UNITED STATES PATENT AND TRADEMARK OFFICE

APPLICATION NO.	FILING DATE	FIRST NAMED INVENTOR	ATTORNEY DOCKET NO.	CONFIRMATION NO.
10/634,967	08/05/2003	Michael A. Cook	0103-0021(ZM0538)	8795

Office Action Summary**Application No.**

DETAILED ACTION

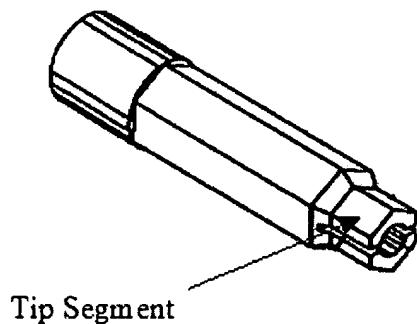
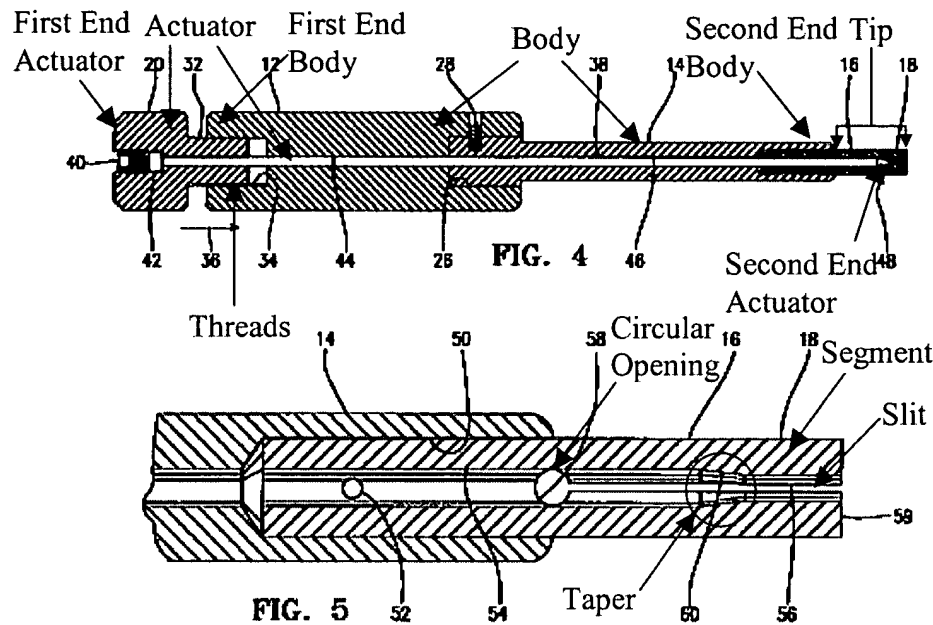
Hajianpour discloses a screwdriver with a holding feature for socket head screws (reference figures 4 and 5 below). Regarding claim 1, Hajianpour shows an instrument with a body (12, 14, 16, and 34) that includes a first end, a second, and an axis between. Hajianpour also shows an engagement tip (16) adjacent to the second end that is receivable by the work piece. The tip (16) is divided by a slit (56) that form segments with the ability to extend outwardly and grip a screw or nail. Regarding claim 2, Hajianpour discloses an instrument that engages a screw or nail in an axial direction. Regarding claim 3, Hajianpour shows an instrument that has a body with a bore (44 and 46) that extends from the first end of the instrument towards the tip of the instrument and continues a predetermined distance past the beginning of the slits (56). Hajianpour also teaches an actuator (20, 32, 38, 40, 42, and 48) having a shaft (38) that is placed

into the bore (44 and 46) of the instrument body (reference figure 4 below). The actuator can be translated axial through the body of the instrument between an unlocked position, in which the actuator is not biasing the tip segments, and a locked position, in which the actuator is biasing the tip segments. Regarding claim 4, Hajianpour shows an actuator that uses threads (32) to engage threads (34) within the body of the instrument (column 4 lines 29-31). Turning the actuator causes it to turn axially between the locked and unlocked positions (column 4 lines 32-34). Regarding claims 5-7, Hajianpour shows that body contains a bore (44 and 46) that contains a tapered section with a larger first diameter and a second smaller diameter. The taper is located past the beginning of the slit (56) located in the tip (16) of the instrument. When the actuator is engaged with the taper, the segments of the instrument tip (16) are expanded outwardly (column 5 lines 3-7). Regarding claim 8, Hajianpour shows an actuator with a tapered end (48) that bias the segments of the instruments tip (16) when engaged with the taper in the bore (44 and 46) of the body. Regarding claim 9, Hajianpour shows the bore (44 and 46) extends completely through the body of the instrument. Regarding claim 10, Hajianpour shows that the slits (56) that through the tip (16) of the instrument terminate with a circular opening (58) to reduce stress concentrations (column 4 lines 51-54). Figure 5 shows the radius of the circular opening (58) to be greater than half the width of the slit (56). Regarding claim 11, Hajianpour shows an instrument tip (16) that engages a screw or nail in a torque transmitting relationship. Regarding claims 12 and 13, Hajianpour shows an instrument tip (16) that has a hexagon shape, reference figure 10 below, which includes flats and vertices to increase the engagement between a screw or nail and the
